***T2 Transformer Upgrade at Wilhaven DS
Notification of Conditional Approval of Connection Proposal
CAA ID Number: 2007-EX320***

ASSESSMENT SUMMARY**Hydro One Distribution Inc.****1.0 GENERAL DESCRIPTION**

Figure 1: Power Factor @ Wilhaven DS - T1

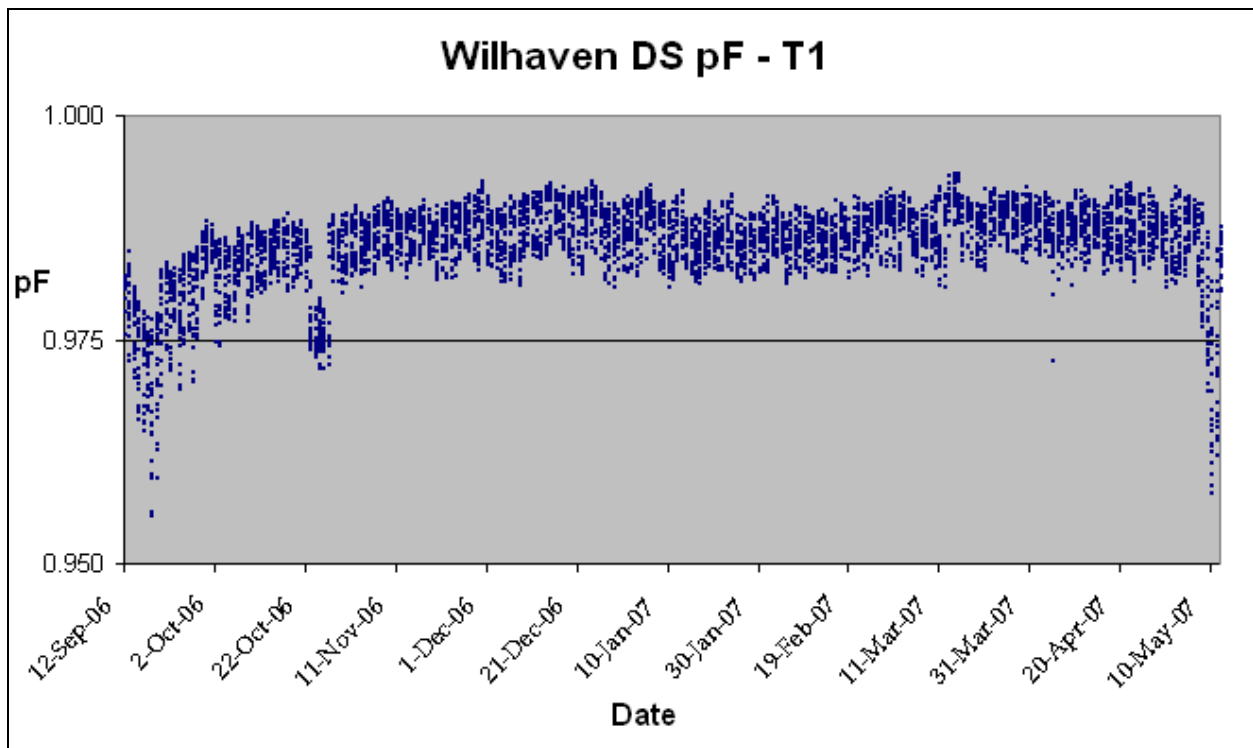
As shown in figures 1 and 2 below, the power factor has been higher than the required 90% lagging as required by the Market Rules at all times except for one occasion.
